SAVANNAH AIRPORT COMMISSION

SAC 30587

RENTAL CAR FACILITY IMPROVEMENTS

ADDENDUM NO. 2

SITE PLAN -
NORTH LOT

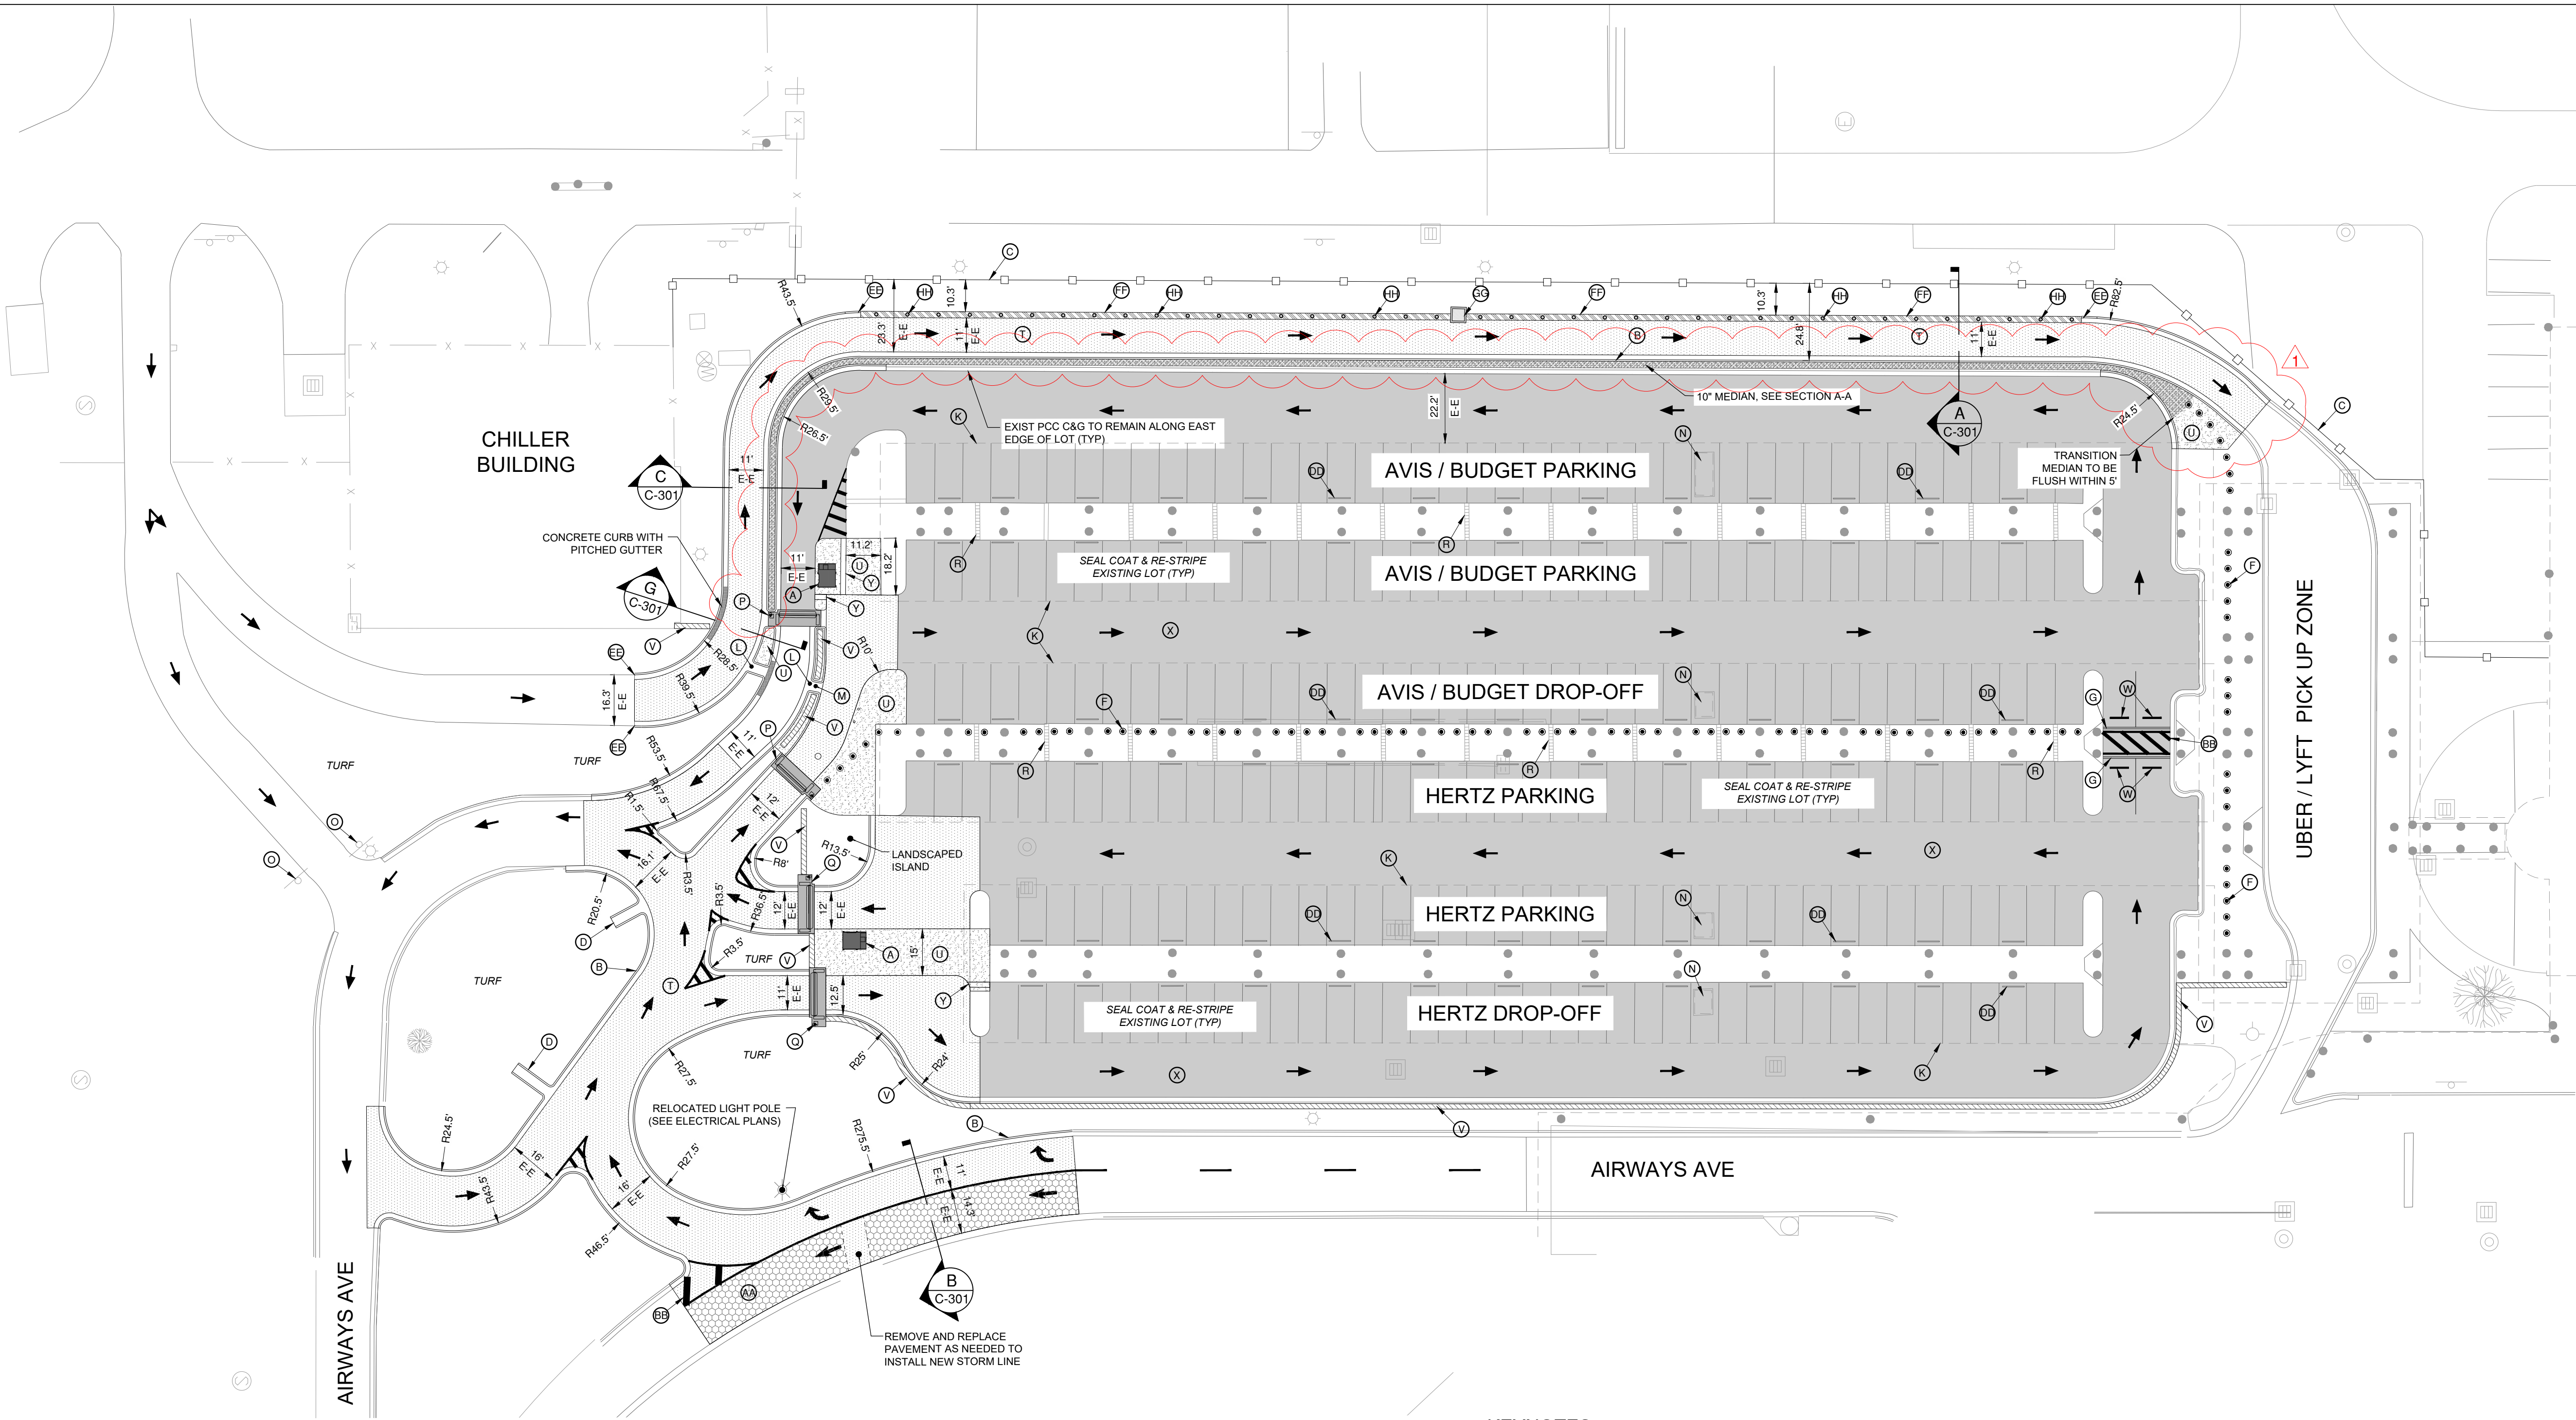
2. Revised Concrete Median Details

2. Revised Concrete Medial Details (follow).
